ADDENDUM NO. 4

Reference: Student Activity Center Addition to the Stromberg Athletic Complex
Weber State University – Ogden, Utah
DFCM Project No. 12031810

Addendum 004

project:	WSU Stromberg Student Activity Center	**project no:**	12475
date:	2012-10-22	**no. pages:**	97
owner:	DFCM		
contractor:			
bid date:	2012-11-01	**bid time:**	12:00 pm

ANTICIPATED EXISTING CONDITION AT STROMBERG ARENA WOOD FLOOR.

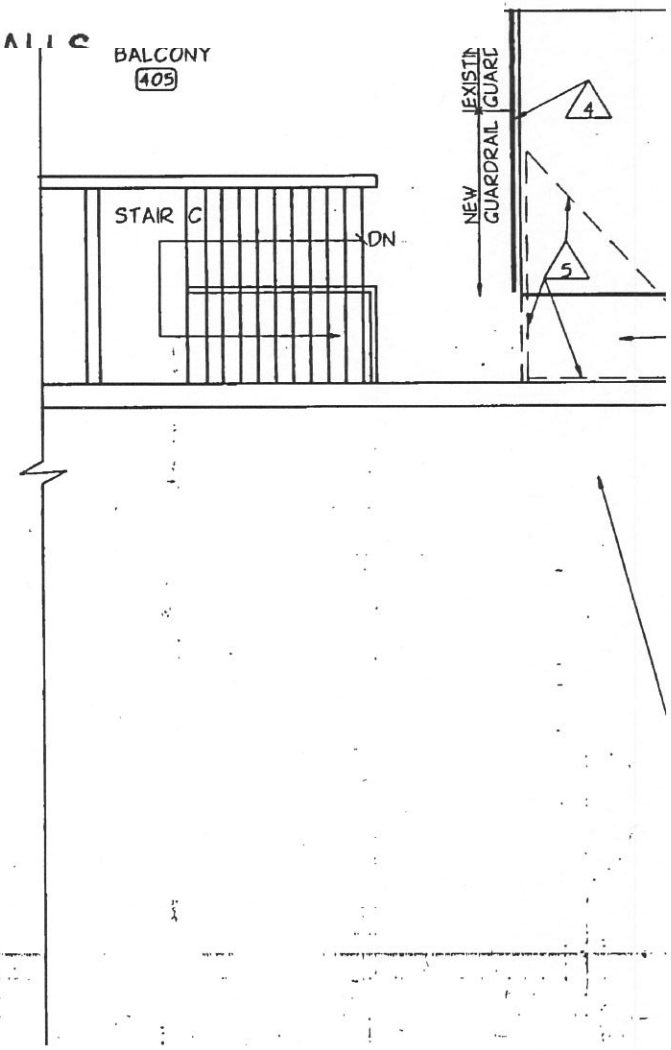
4.5	QUESTION: Please provide a detail showing the construction of the existing floor inside Stromberg Gym at the basketball court area. We need to know what floor system was used to know what load this floor can handle during construction. RESPONSE: The existing conditions drawings are posted on the DFCM website for reference. Attached is the detail at the gym floor. These drawings indicate the slab thickness to be 4". NOTE: Contractor is to protect the athletic wood floor AND the synthetic running track surface or replace any damage that occurs.

A104.1

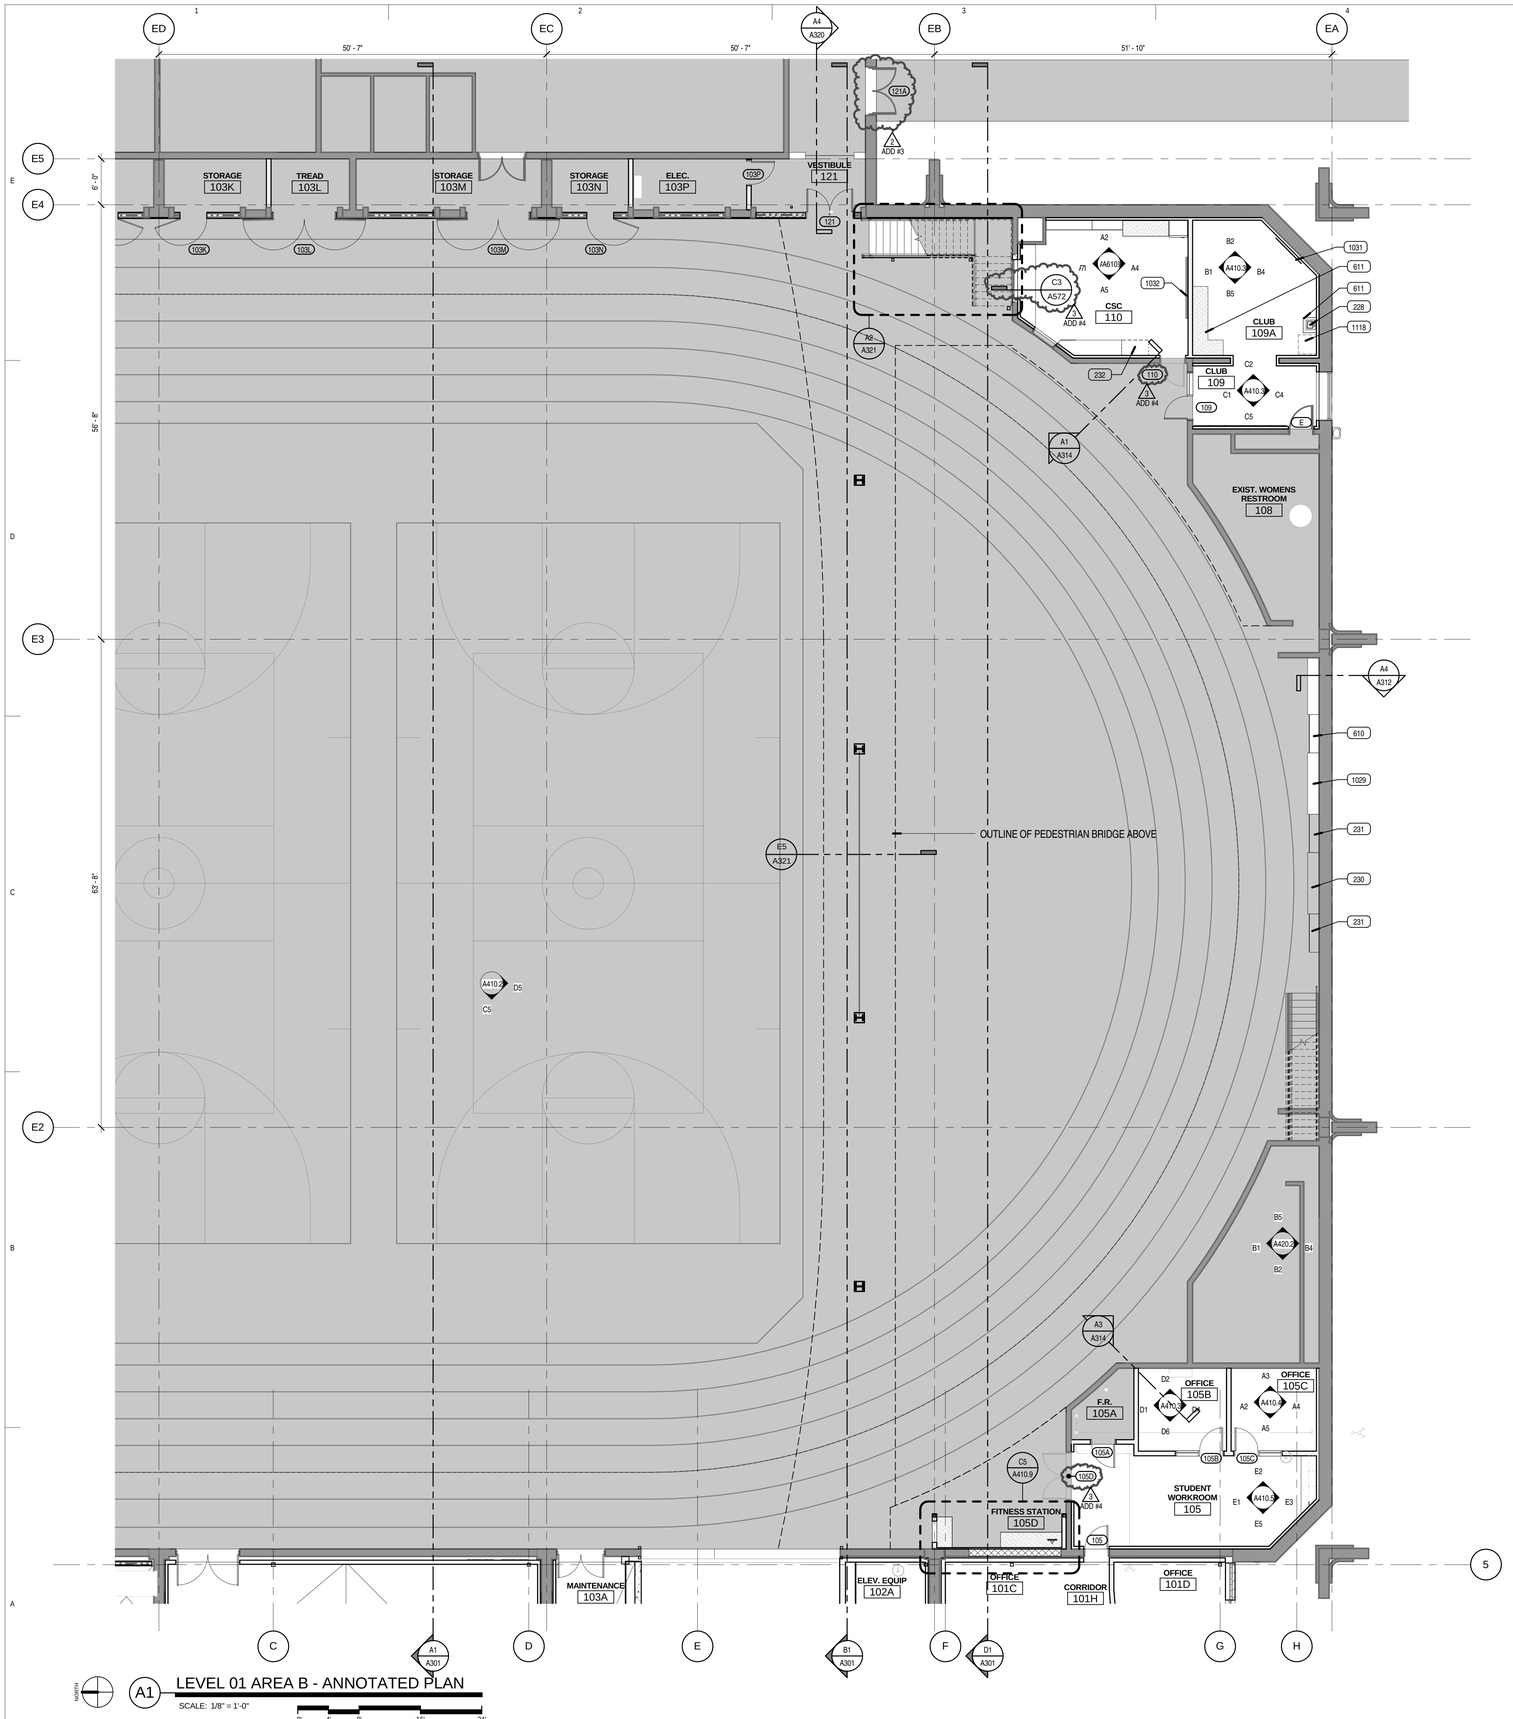
4.3	A104.1	See attached revised sheet for added tubular daylight system location, at north stair.
4.3	A112.2	See attached sheet for revisions to doors, and new detail tag at window CSC 110.

BUILDING ELEVATIONS

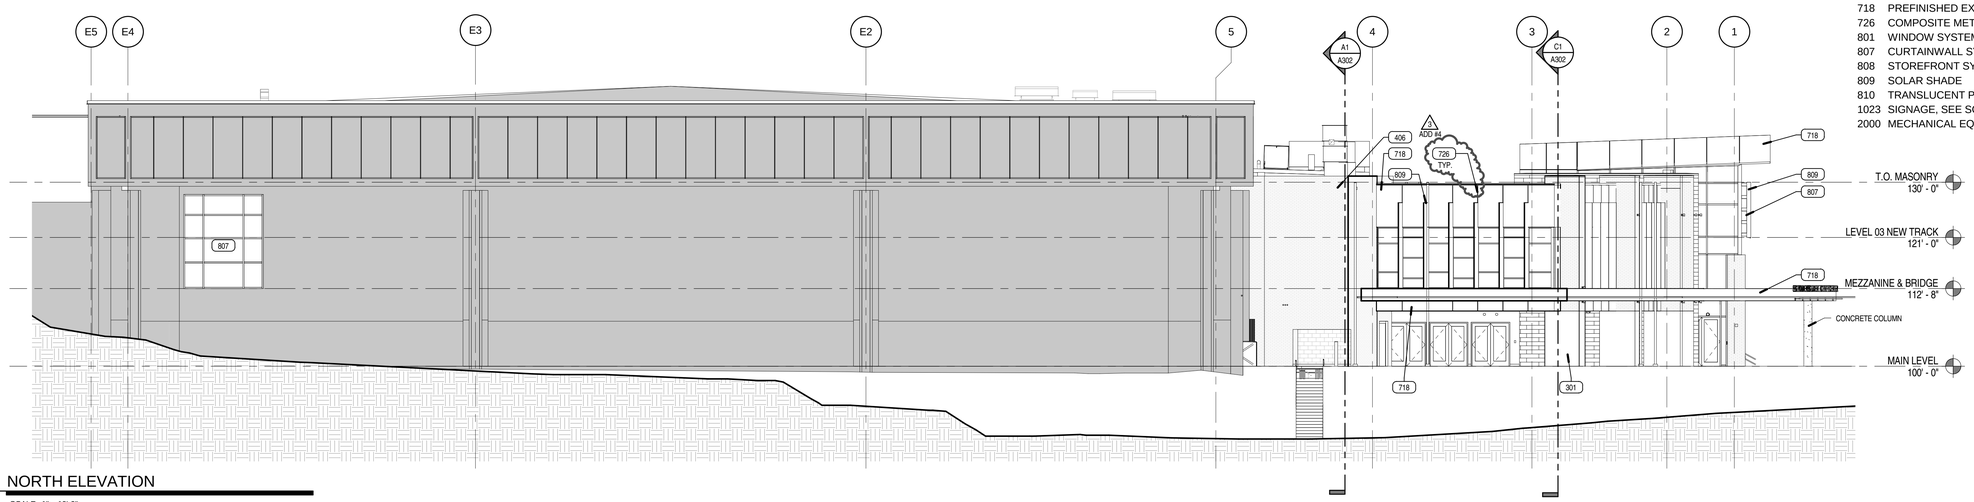
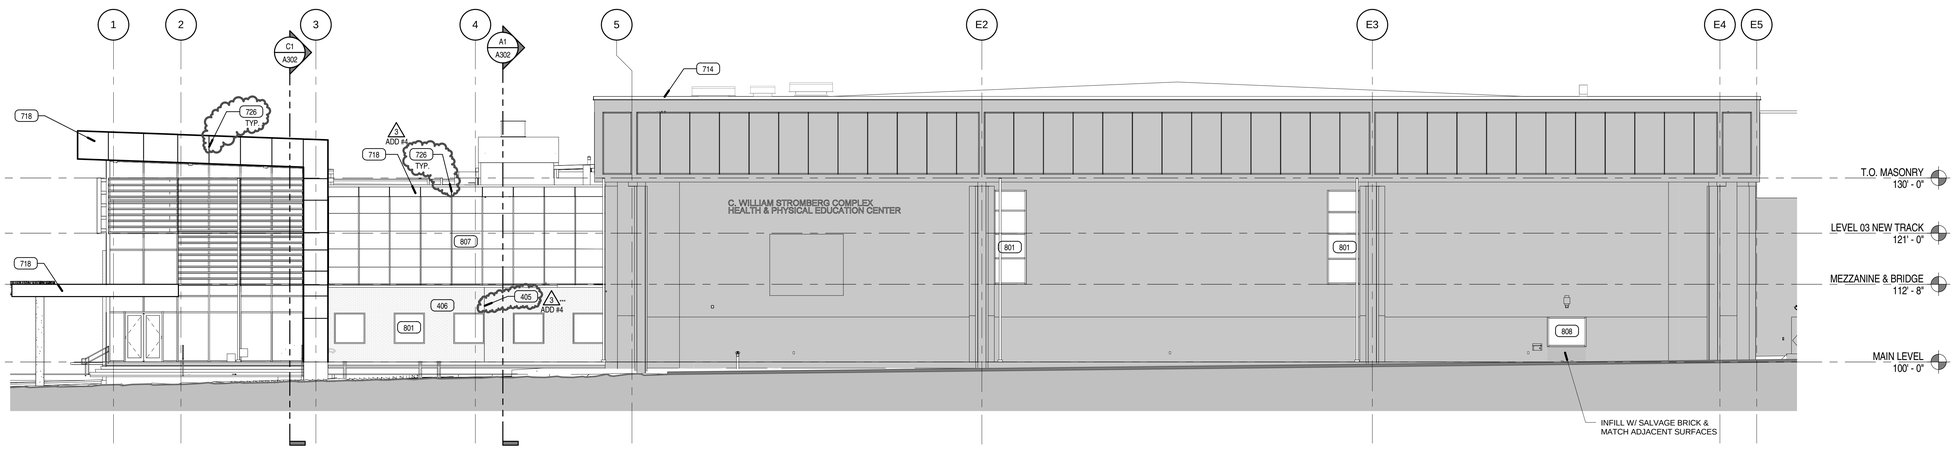
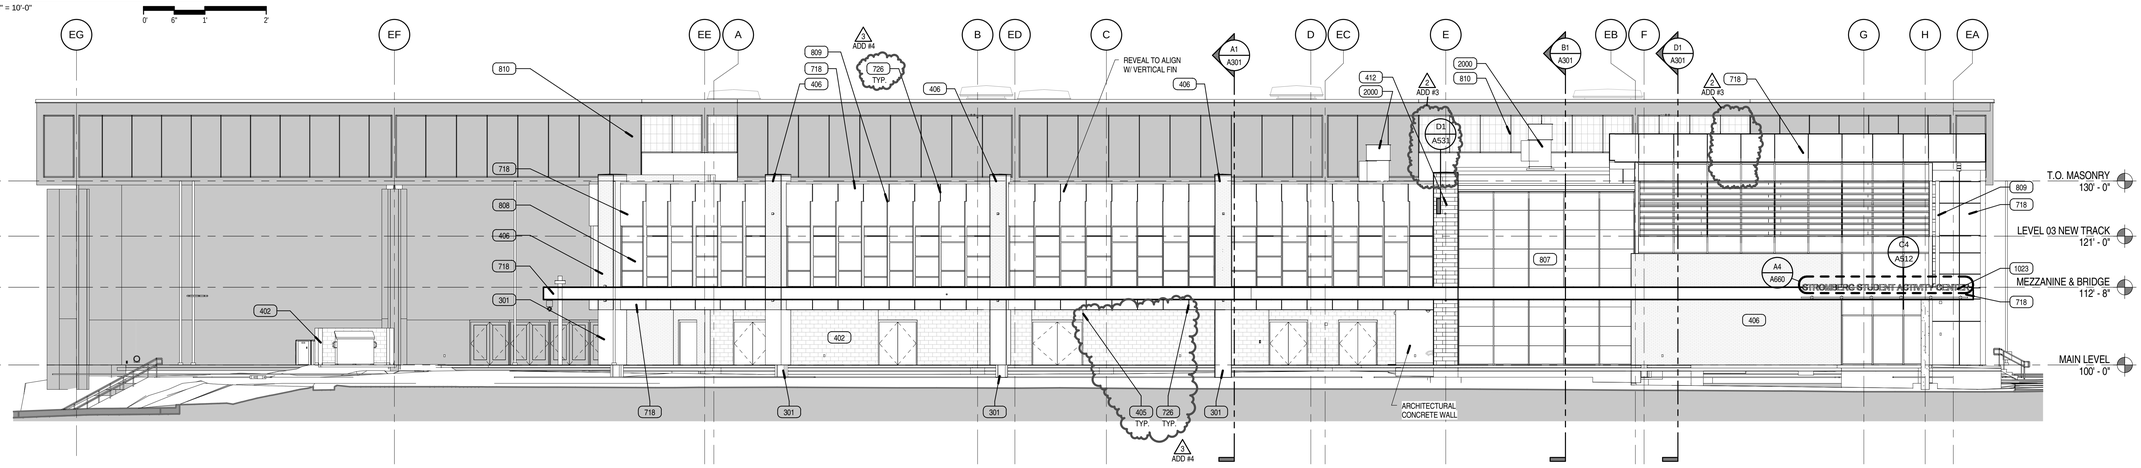
4.7	A201	See attached for revised elevations A1, B1 and D1/A201.
4.9	A301	See attached for revised Section D1, revisions to the elevator shaft at roof and adjacent elements.

A1 WS ADDITION WEST GRID F.2
SCALE: 1/2" = 1'-0"

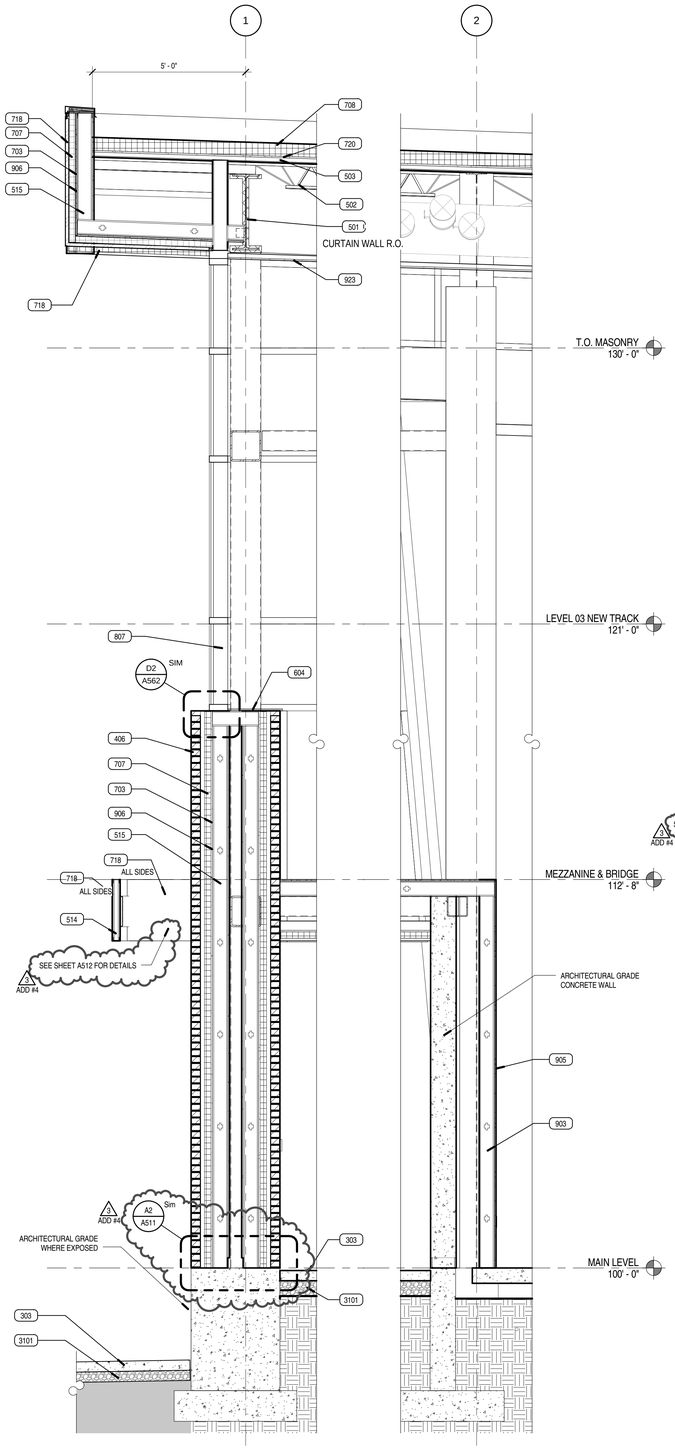
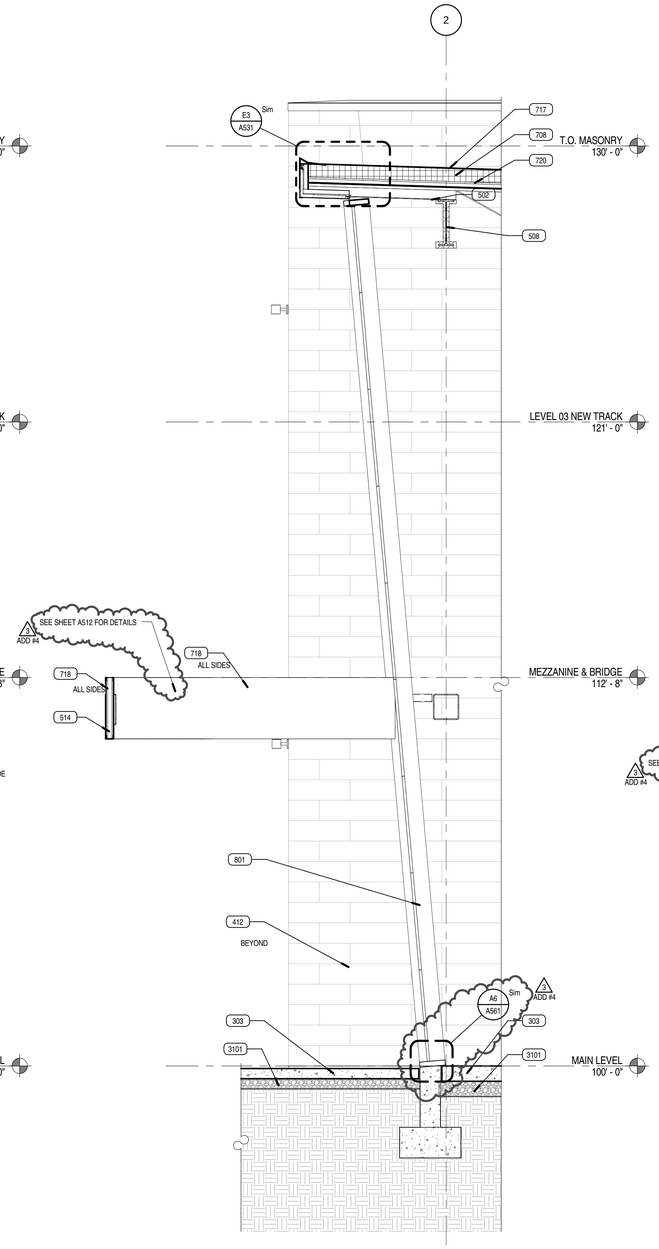
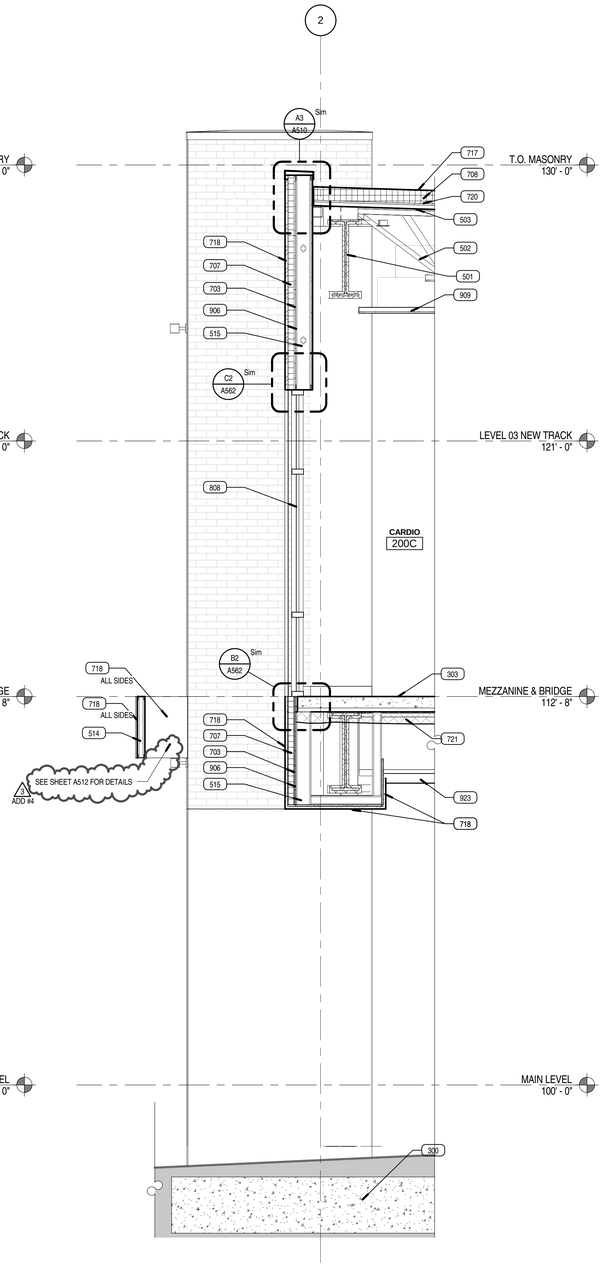
4.9	A313	See attached for revised details A1, A3, A5 and A6.
4.9	A314	See attached for revised details A5 and A6.
4.10	A315	See attached for revised details A2 and A5.

A2 FOUNDATION WALL @ BRICK VENEER

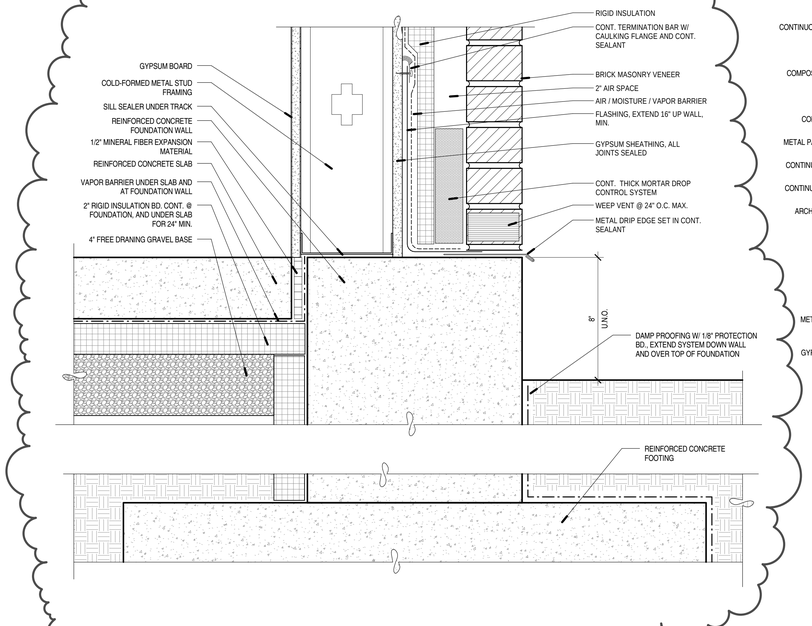
4.11	A510	See attached for revised details A2, A6, C2, E3 and E5.
4.13	A511	See attached for added Details A2, C2 and D6, and revised details A5 and B5.
